**Talbot Field Development D/4273/2021, Harbour Energy response to Notice Under Regulation 12(3)**

This letter has been prepared in response to the notice received on 17<sup>th</sup> January 2023 from the Offshore Petroleum Regulator for Environment and Decommissioning (“OPRED”) under section 12(3) of The Offshore Oil and Gas Exploration, Production, Unloading and Storage (Environmental Impact Assessment) Regulations in relation to the Talbot Field Development Environmental Statement.

**Figure 1 – Bathymetry of Talbot Appraisal Drill-Site Location**

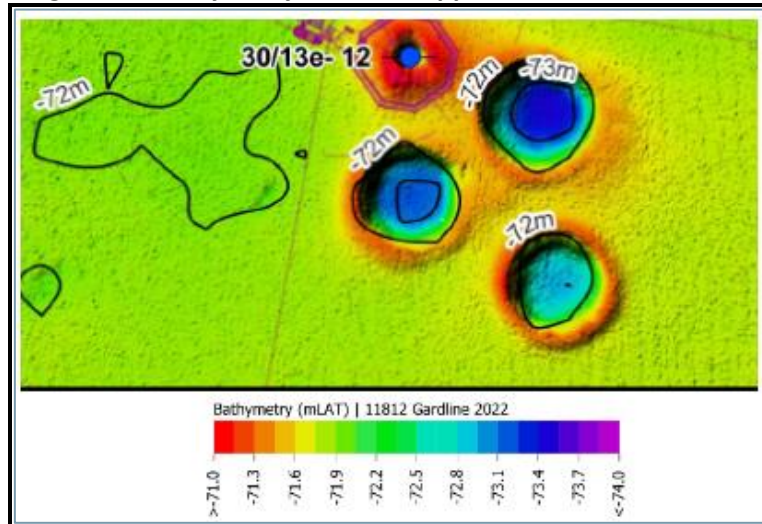
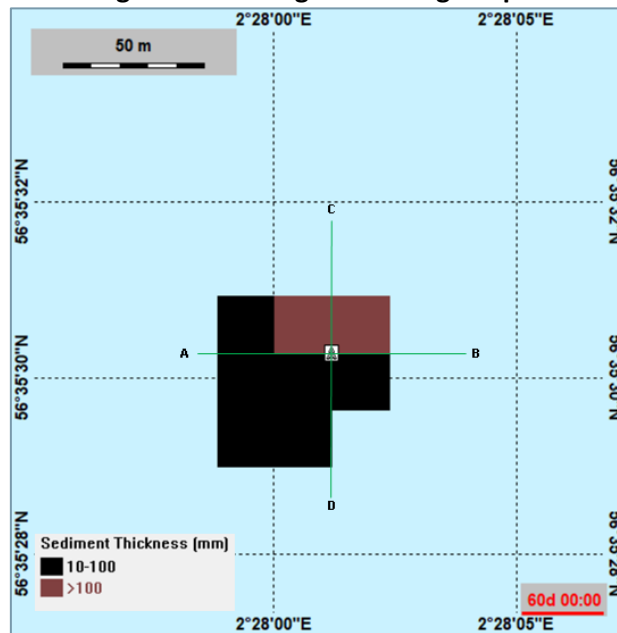
**OPRED Comment 6: “Section 3.5.5 – The cuttings transportation system mentioned here should be described in further detail, with information given on its use including the predicted location, nature, scale and extent of the discharged cuttings resulting from its use.”**

Cuttings modelling has been undertaken to demonstrate predicted location and scale of cuttings deposition. The cuttings transportation system (CTS) is now unlikely to be utilised, but its use represents a worst-case in terms of cuttings deposition away from the well site and largest impact area; therefore we have used this as a precautionary assessment approach for cuttings modelling. The DRA applications for the Talbot wells have detailed descriptions of the cuttings transportations operating system and cuttings deposition associated with its use. In summary the system pumps cuttings as they are generated away from the wellsite at the drilling template up to about 60m. The system capacity can equal the rate of the cuttings being generated.

In terms of impact - the use or non-use of the CTS doesn't make a significant difference. It is the same volume of cuttings and in terms of MCZ impact is still effectively very localised due to discharge of cuttings directly to seabed in the immediate vicinity of the well site and rig location as opposed to cuttings being discharged from the rig at sea level and then descending through the water column where a much larger area (of thinner cuttings) is the result.

Modelling was undertaken for 3 wells discharges using a ParTrack module within SINTEF's Dose related Risk and Effect Assessment Model (DREAM). The results gave a cuttings pile of two peaks, due to the bidirectional horizontal discharge ports of the CTS. The Environmental Impact Factor predicted was zero- suggesting the seabed impact from drilling of the Talbot wells was very small. If the CTS is deployed, then it will be located on the seabed approximately 60 m from the Talbot template centre point and the cuttings will be discharged at one location simultaneously out of two discharge ports in easterly and westerly directions.

Xodus modelling (Xodus, 2022) showed that the cuttings and mud produced from the drilling of the three Talbot TA, TB and TC wells are predicted to produce one cuttings pile discharged from the CTS. The cuttings pile above the 10 mm threshold for burial of non-mobile organisms is approximately 60 m in diameter. Due to the mud and cuttings being discharged from one location horizontally in opposing directions at the CTS, the cuttings pile produced is not an elongated conical mound as is typical of vertical mud and cuttings discharges at the seabed but is composed of two peaks. The thickest area of mud and cuttings pile is predicted to be predominantly formed to the immediate east and west of the CTS location if that is the position of the discharge points (as modelled). The maximum thickness of the cuttings pile peaks are 1,371.5 mm and 1,351.6 mm, which rapidly decrease to <2 mm within 400 m of the discharge point (Xodus, 2022). The direction of the wider-scale deposition of sediment is dominated by prevailing currents to the south-east at levels that are not easily detectable in the environment.

Therefore, where the cuttings are thick enough to have any potential seabed impacts, they are likely to remain highly localised to the discharge point. Impacts on the MCZ's designated features, specifically the ocean quahog will therefore be insignificant on a population basis given the small area impacted. The Talbot appraisal well was surveyed 60 days after the rig left and this clearly shows

cuttings around the well site to a thickness of approximately 1.3m but very little change in seabed depth immediately (a few metres) from the well site suggesting a very small impact area (no CTS was used in the appraisal well). This Survey visual is included in the figures supporting this response (Figures 1 and 2).
